Access Compliance Report

Public Rights-of-Way

(Curb Ramps)

Intersection ID: 11980	Main Street: ALLEN_ST	Cross Street: E_17TH_ST	Location: E
ADA ID: 9FFB58C4ABFD	Ramp Type: Directional1	Initial Pass/Fail: Pass	Overall Compliance: No
Severity Score: 2.5			
Codes/Mitigation Info/Possible Solution		Field Measurements/Component Compliance

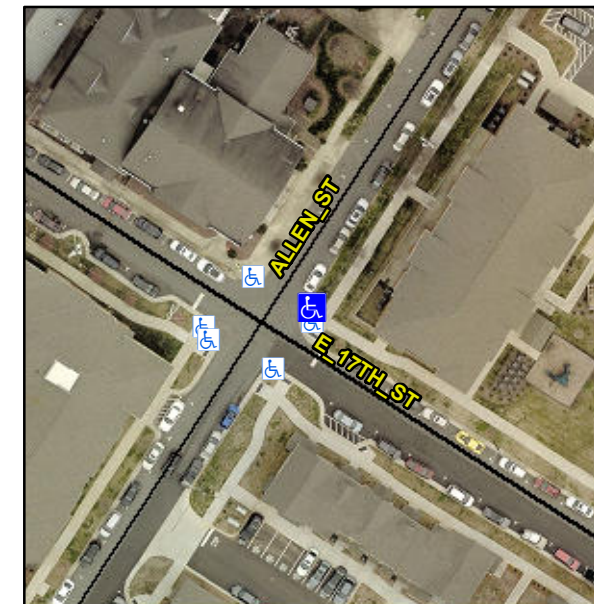
R304.5.3, R305.1.4

Compliance	Description	Data	Compliance	Description	Data
N/A	Ramp Length (in)	83.0	Yes	Grade Break?	Yes
Yes	Ramp Width (in)	71.0	Yes	Grade Break Slope (%)	1.6
Yes	Ramp Slope (%)	4.0	No	Grade Break XSlope (%)	3.2
Yes	Ramp XSlope (%)	0.8			
Yes	Flare Type LT	N/A	Yes	Flare Type RT	N/A
N/A	Flare Slope LT (%)	N/A	N/A	Flare Slope RT (%)	N/A
N/A	Flare Traversable LT?	No	N/A	Flare Traversable RT?	No
Yes	Landing Length (in)	71.0	Yes	DWS Provided?	Yes
Yes	Landing Width (in)	72.0	Yes	DWS Contrast?	Yes
Yes	Landing Slope (%)	0.1	Yes	DWS Length (in)	24.0
Yes	Landing X Slope (%)	0.0	No	DWS Full Width?	No
N/A	Landing Curb? (Y/N)	No	Yes	DWS Offset LT (in)	12.0
N/A	Shared Landing?	Yes	Yes	DWS Offset RT (in)	1.5
Yes	Gutter Ponding?	No	Yes	Gutter Slope (%)	2.9
Yes	Gutter Lip Ht (in)	0.0	No	Gutter X Slope (%)	4.0
N/A	Painted X Walk1?	No		Road Slope (%)	2.6
	X Walk 1 Direction	To NW		Road X Slope (%)	1.9
	X Walk 1 Width (in)	N/A		Clear Space?	Yes

X Walk 1 Slope (%)	2.6	N/A	Clear Space to XWalk (in)	N/A
	X Walk 1 X Slope (%)	1.9	Yes	Storm Grate/Utility Hazard?	No
N/A	Ramp inside XWalk1?	N/A		Storm Grate/Utility Type	
Yes	Any Obstructions?	No			N/A
	Obstruction Type		Yes	Surface Condition? (G/P)	Good
			N/A	Curb Slope (%)	2.0

**Remove & Replace Entire Ramp.
Remove & Replace Gutter.**
